UNITED STATES  
ATOMIC ENERGY COMMISSION  
WASHINGTON, D.C. 20545

August 26, 1971

NIAGARA MOHAWK POWER CORPORATION  
DOCKET NO. 50-220

ASSIST INSPECTION - NINE MILE POINT - LIQUID WASTE SYSTEMS  
DOCKET NO. 50-220

FIGURE I

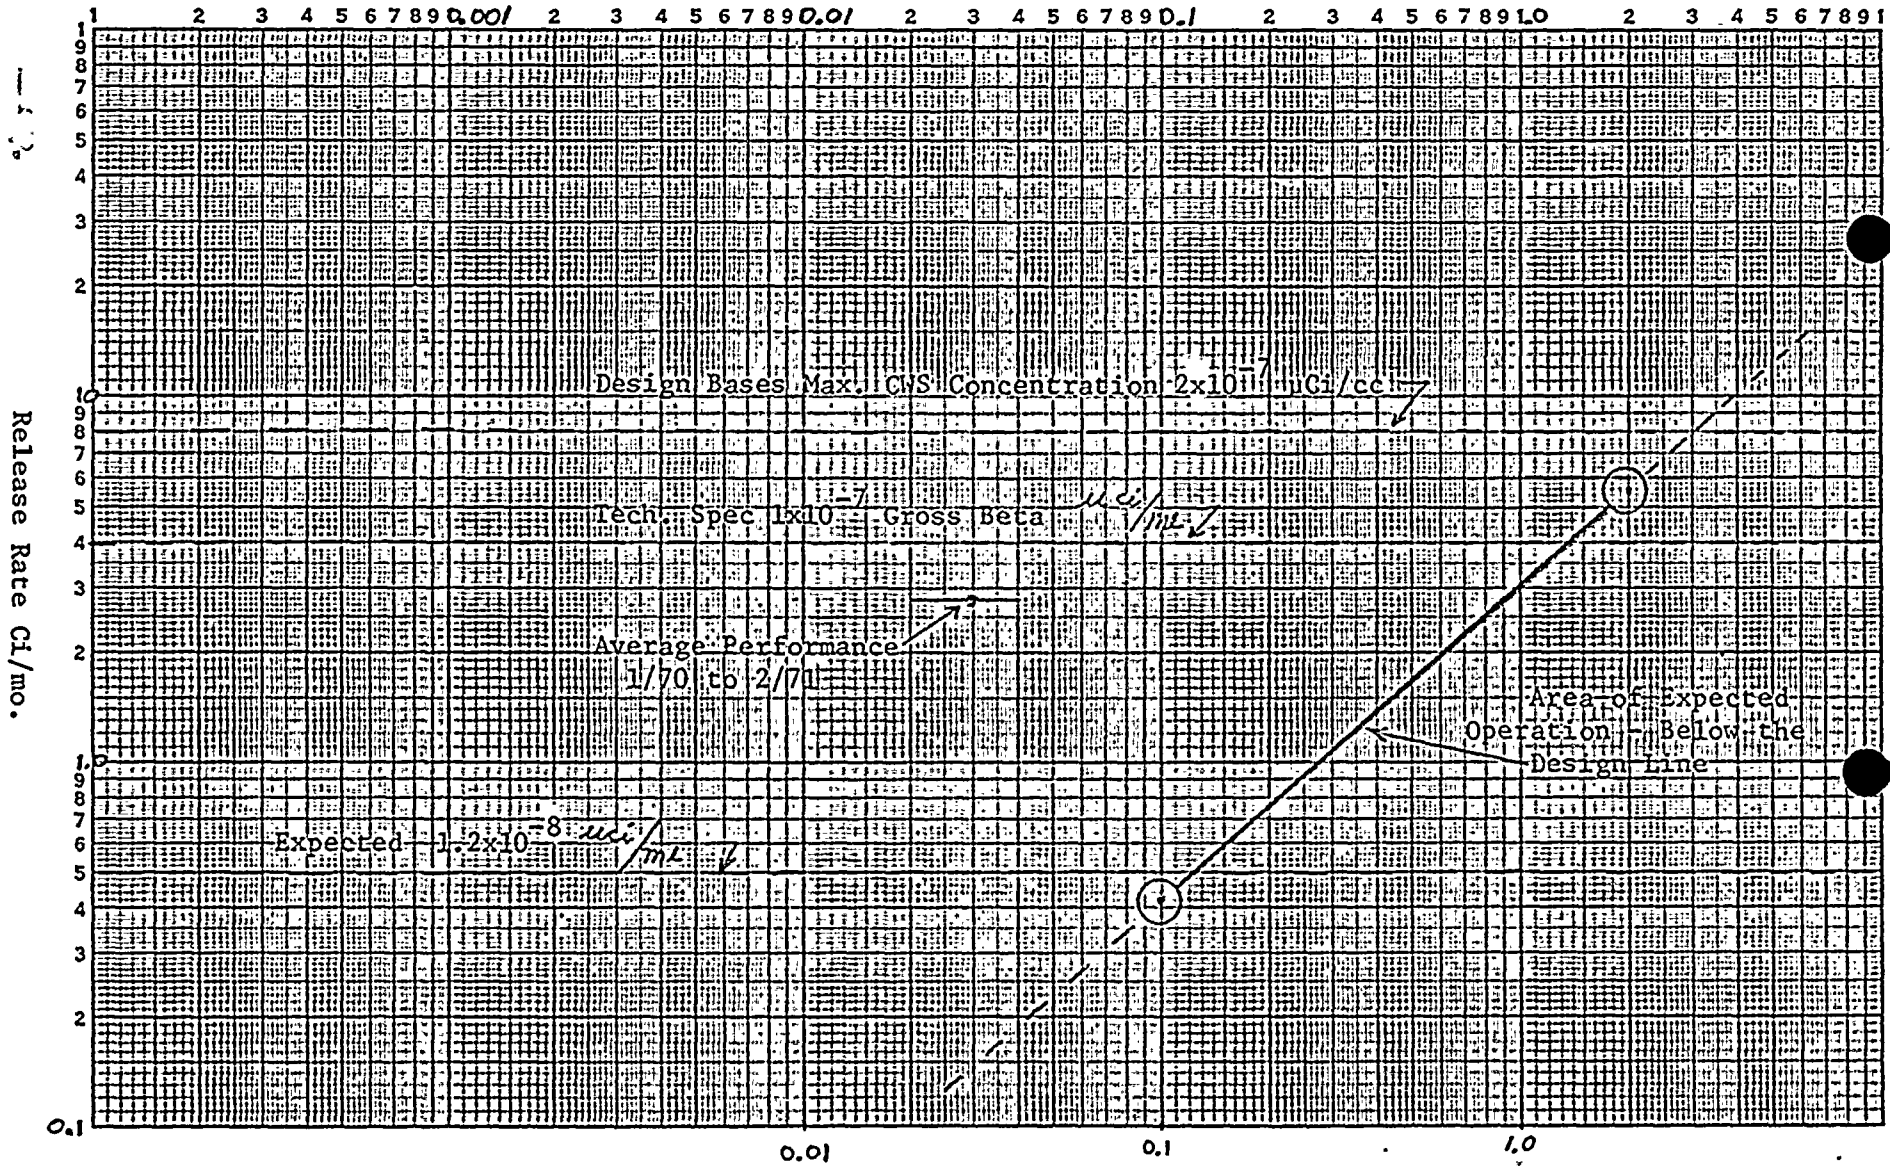
A review of the liquid radwaste system design objectives was made and compared with system performance. The review of the design objectives<sup>4/</sup> indicate that the expected liquid release rate for the fuel failures experienced to date (as measured by the activity in the primary coolant) is approximately 0.2 curies per month. The average performance during this period (the past 14 months) has been 2.8 curies per month. (See chart - Figure 1).
